RICHMOND COMMUNITY SCHOOL
Richmond High School: Mechanical Modernization Project
LWC Commission No. 20104.02

ADDENDUM #02
September 24, 2021

LWC, Inc.
712 EAST MAIN ST
RICHMOND, IN 47374

Comm. No.	Date	
20104.02	9.10.2021	
Drawn	JLK	Drawing No.
Checked	NPR	M303

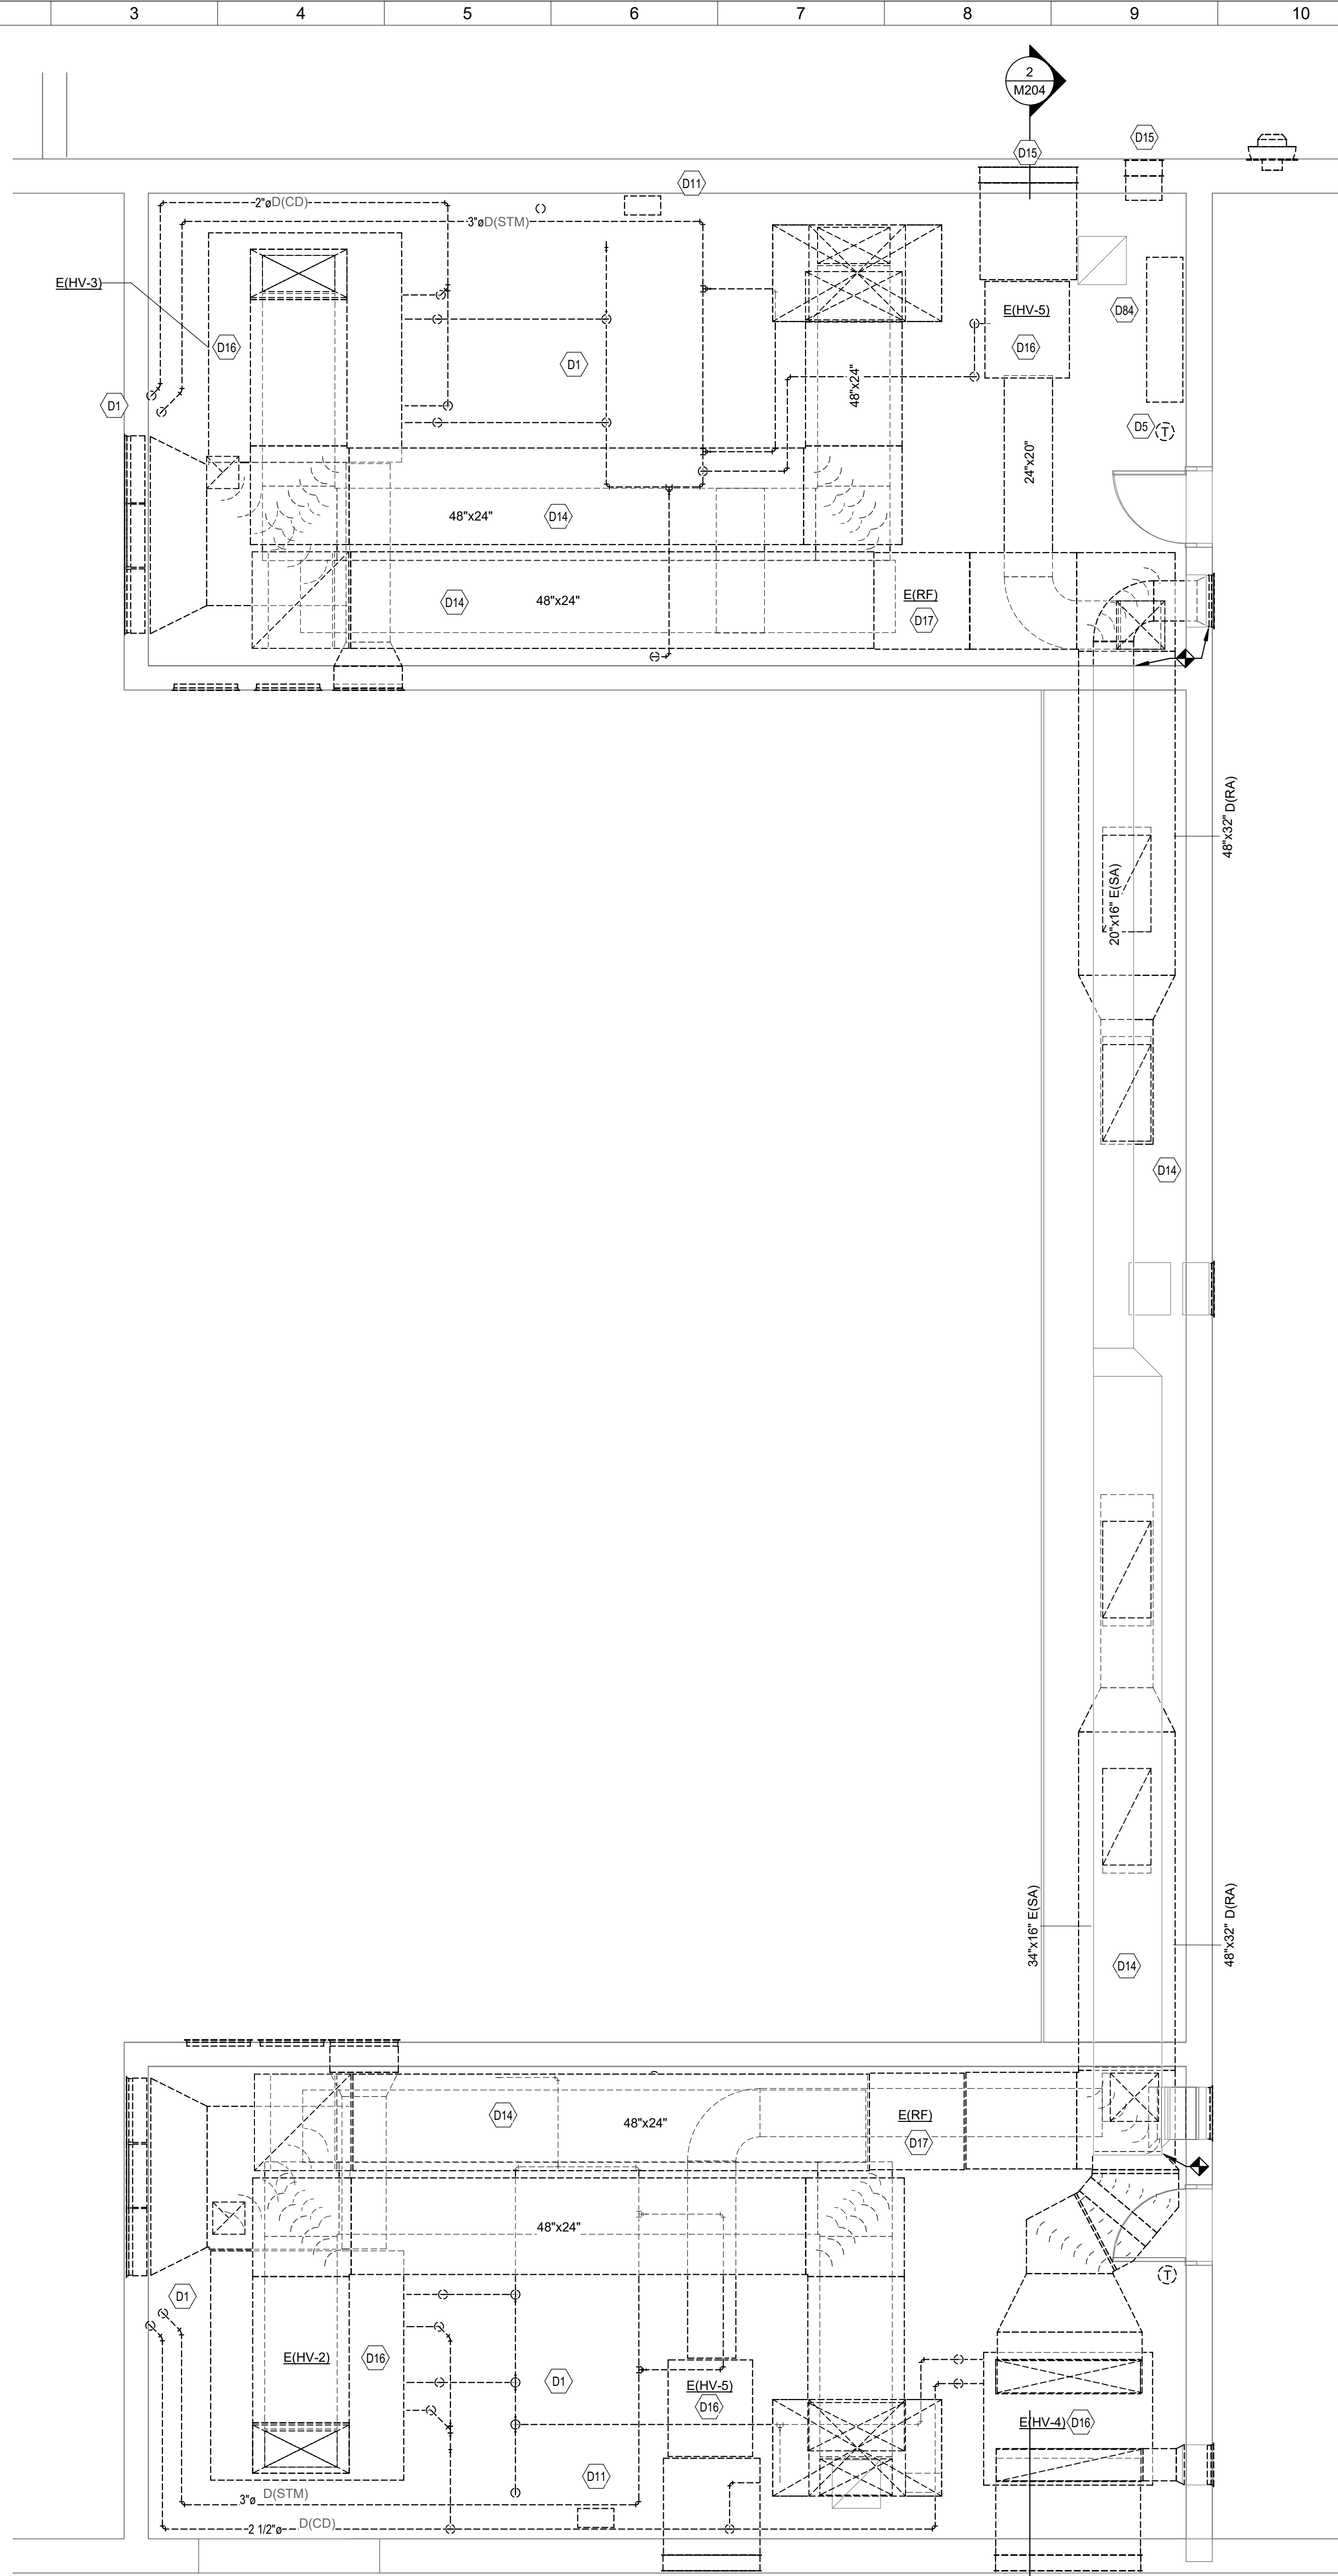
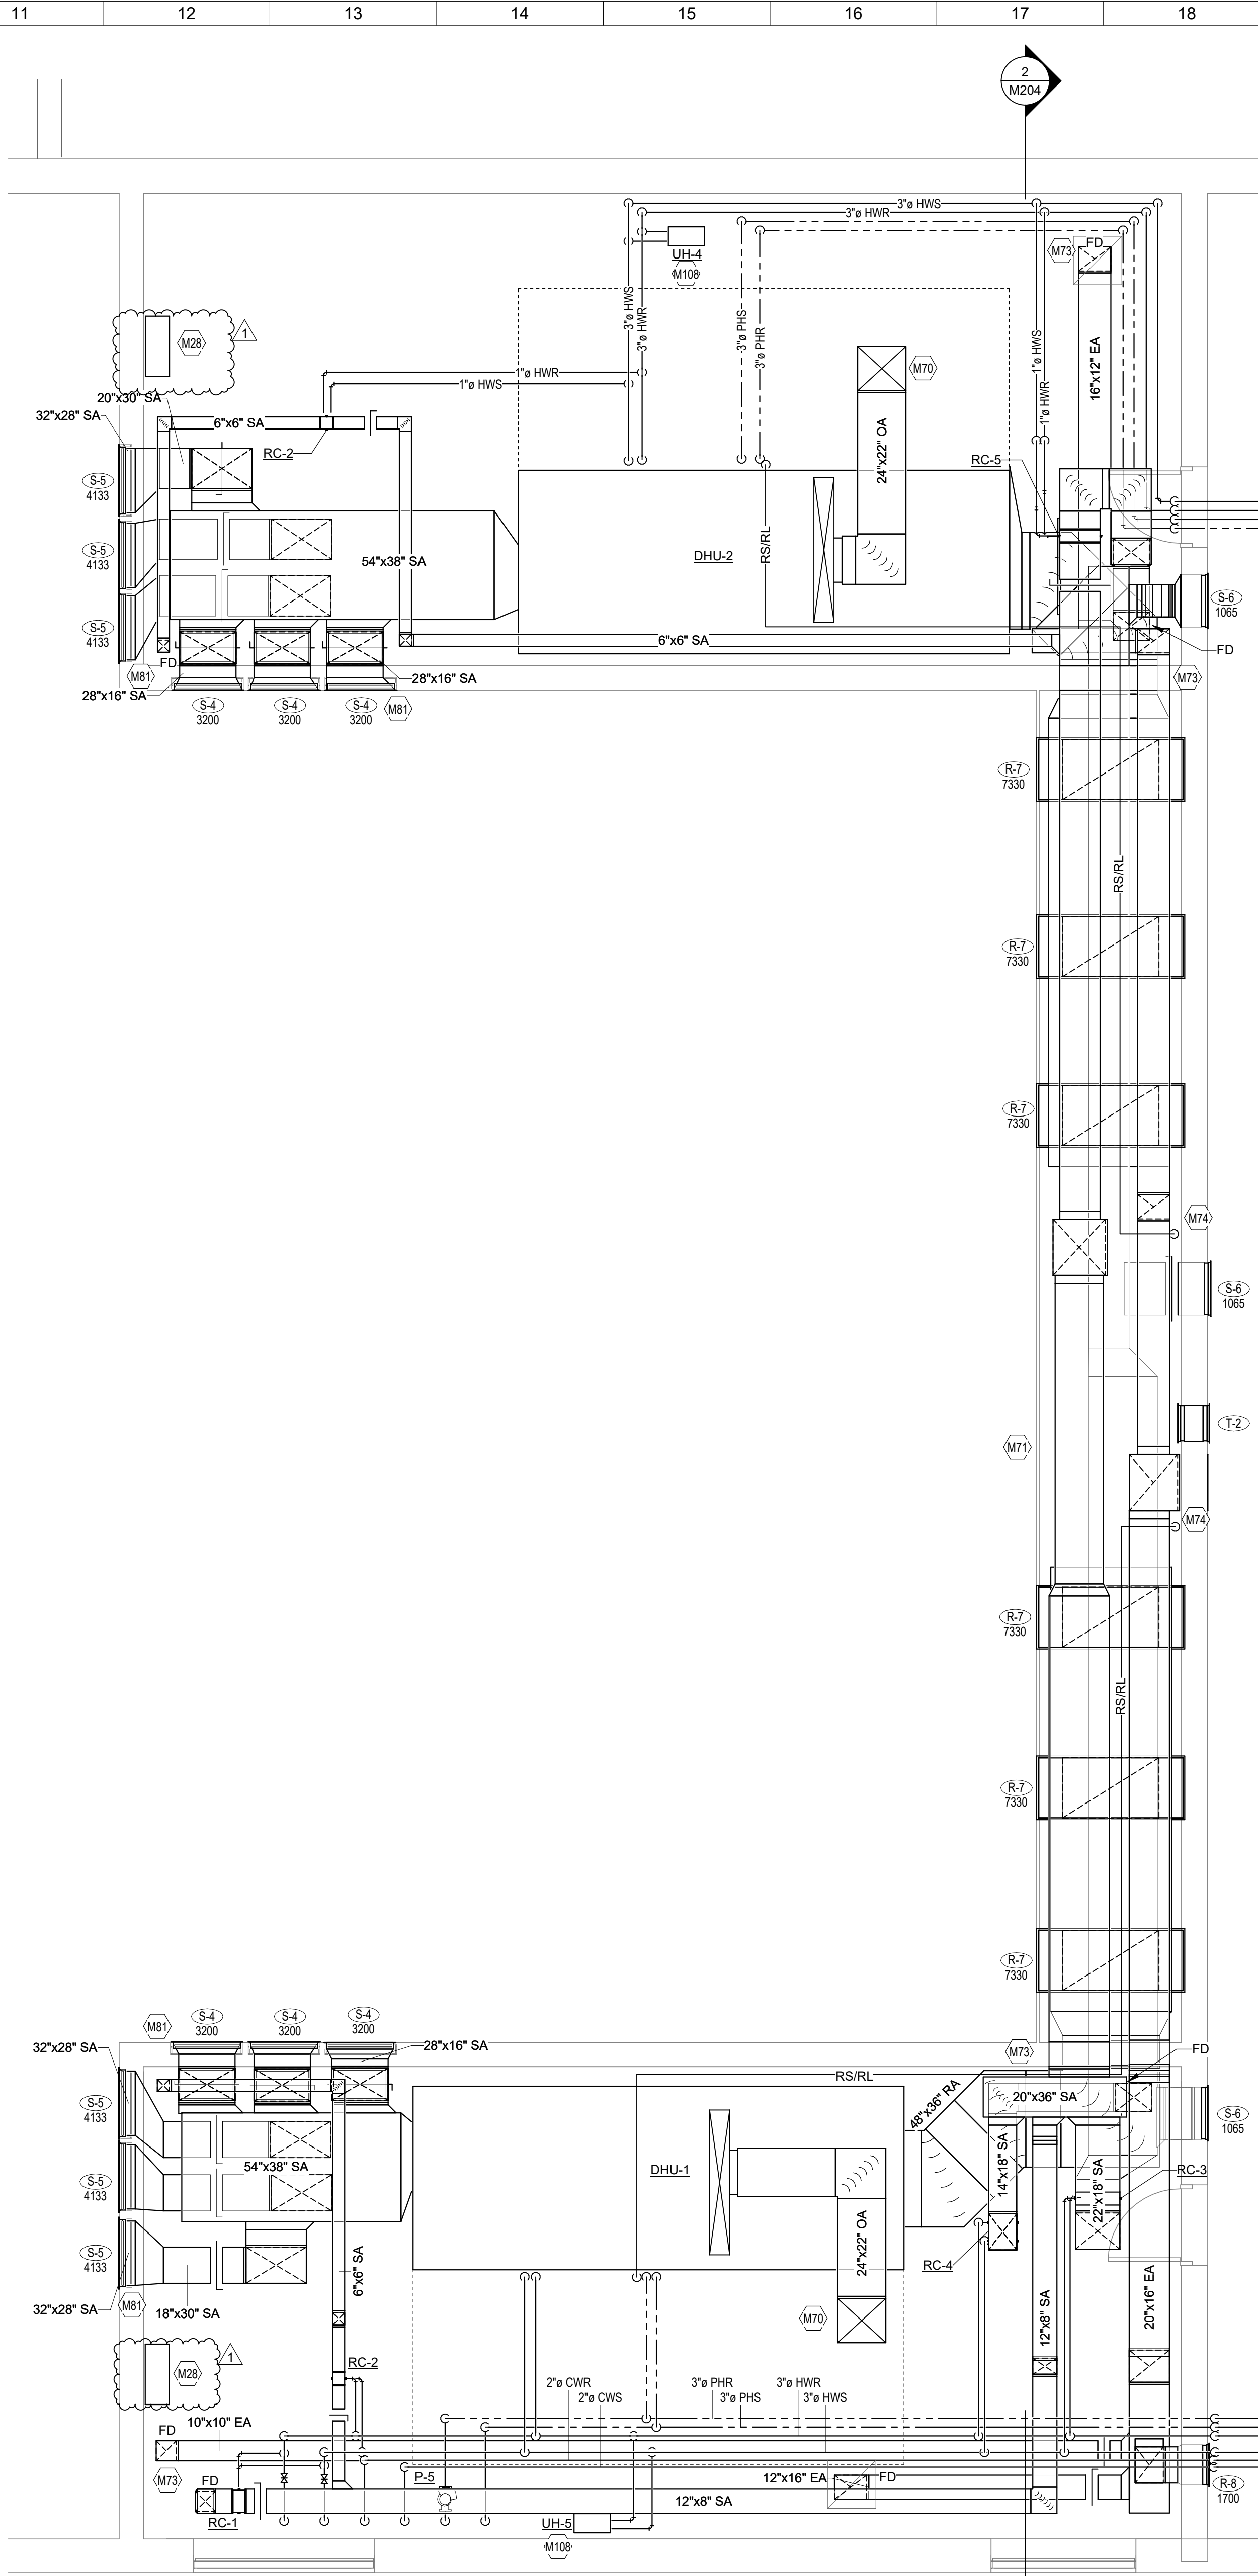
- A. BAS panel added in each mechanical room.
